ADDENDUM NO. 3
TO THE CONTRACT DOCUMENTS
for the construction of the
NAMPA WWTP PHASE I UPGRADES:
GROUP A—LIQUID STREAM UPGRADES

Date: February 27, 2015
Project No.: 480770

C SECTION
1" = 5'
050-D-109

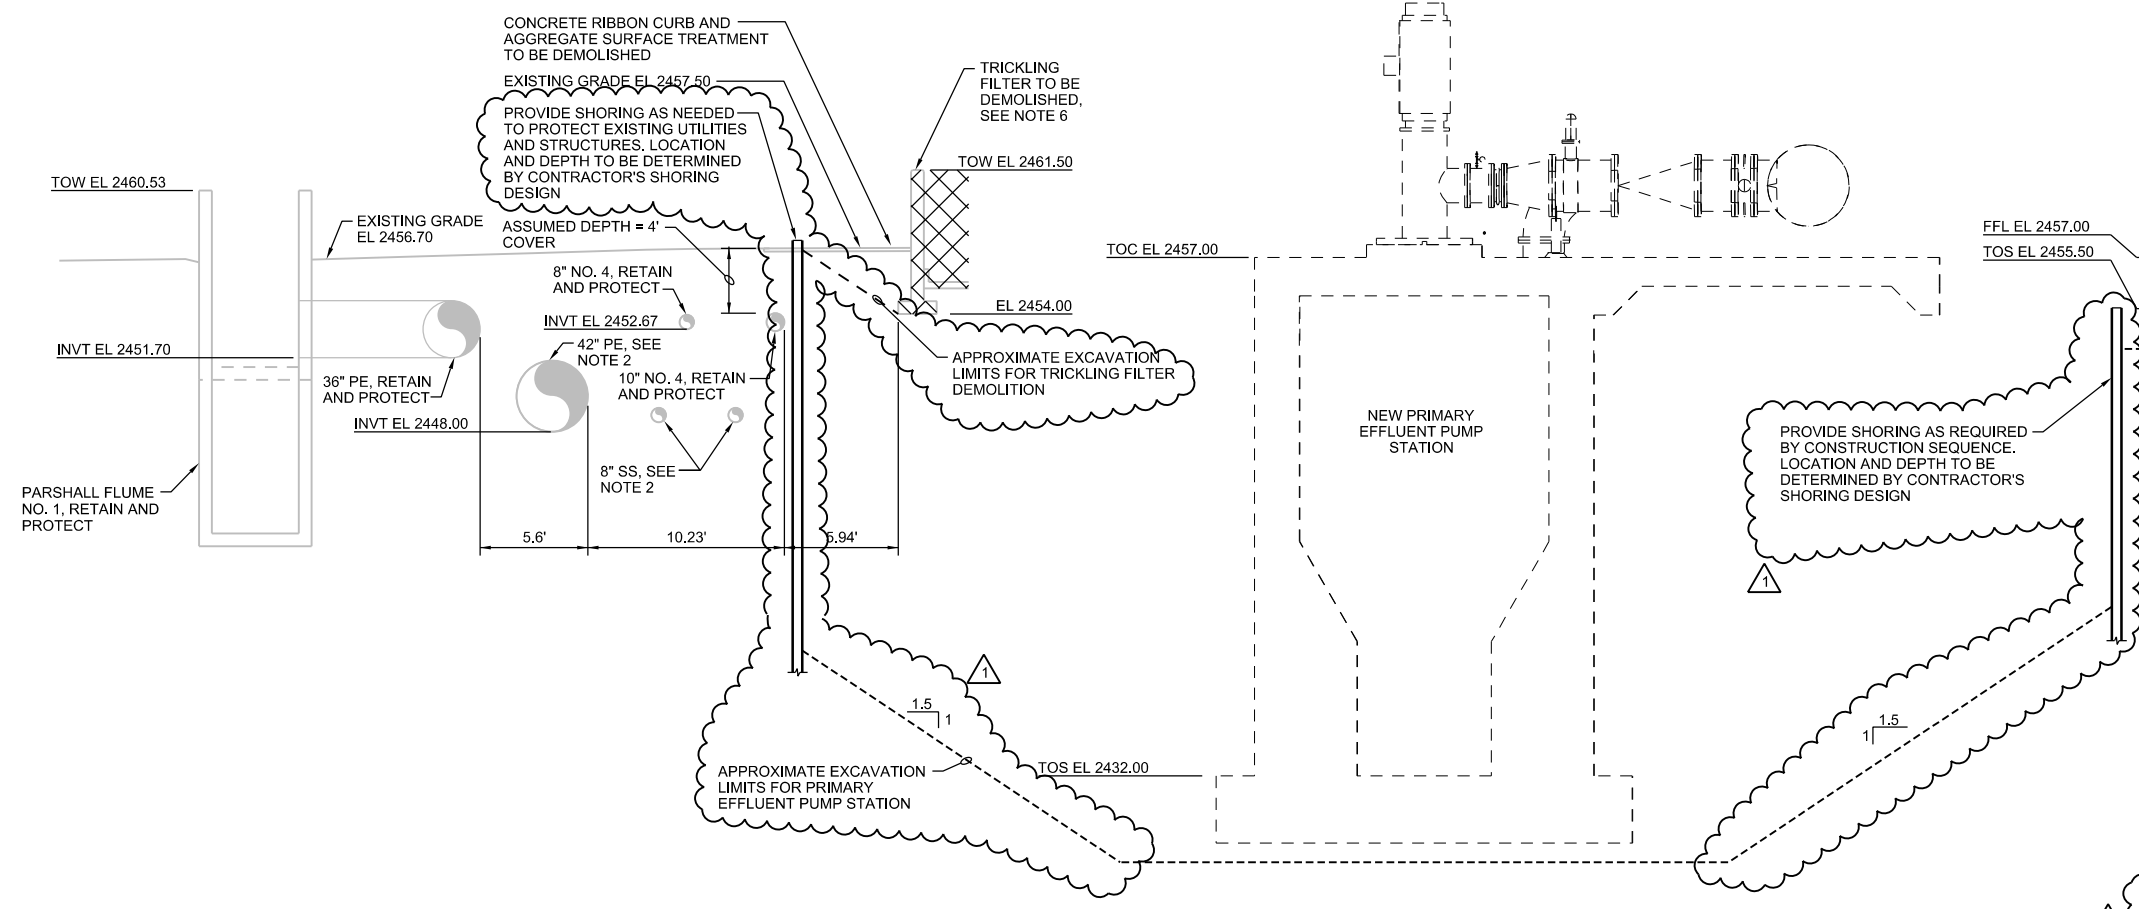
- NOTES:
- ELEVATIONS AND LOCATIONS OF EXISTING STRUCTURES AND UTILITIES ARE APPROXIMATE. CONTRACTOR TO FIELD VERIFY PRIOR TO CONSTRUCTION.
 - PLAN SHEETS SHOW DEMOLITION OF 42" PE AND BOTH 8" SS PIPES, HOWEVER, ALL PIPING SHOWN IN THIS DETAIL TO BE RETAINED AND PROTECTED DURING DEMOLITION OF TRICKLING FILTER. DEMOLITION TO OCCUR AT A LATER DATE. SEE SPECIFICATION SECTION 01 31 00 CONSTRUCTION SCHEDULE AND CONSTRAINTS, FOR DEMOLITION AND CONSTRUCTION SEQUENCING. CONTRACTOR TO PROVIDE A PLAN FOR THE TEMPORARY REROUTING OF THE 8" AND 10" NO. 4 WATER LINES TO FACILITATE THE DEMOLITION OF THE 2-8" SS PIPES.

E AB 3 DEMOLITION SECTION
1" = 10'
050-D-109

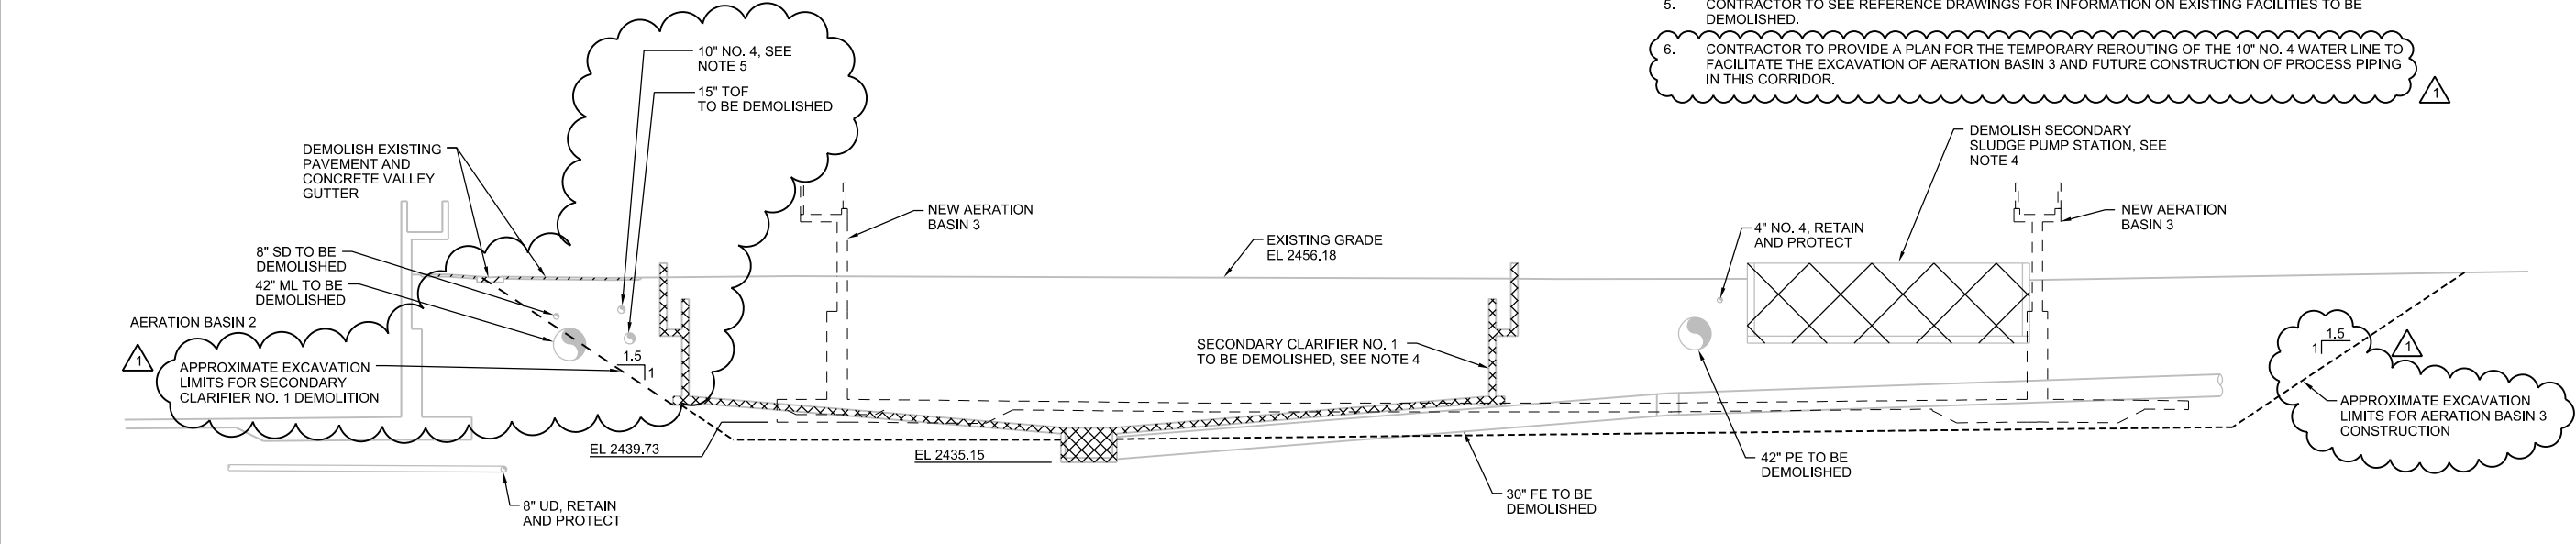
- CONTRACTOR TO SEE REFERENCE DRAWINGS FOR INFORMATION ON EXISTING FACILITIES TO BE DEMOLISHED.
 - CONTRACTOR TO PROVIDE A PLAN FOR THE TEMPORARY REROUTING OF THE 10" NO. 4 WATER LINE TO FACILITATE THE EXCAVATION OF AERATION BASIN 3 AND FUTURE CONSTRUCTION OF PROCESS PIPING IN THIS CORRIDOR.
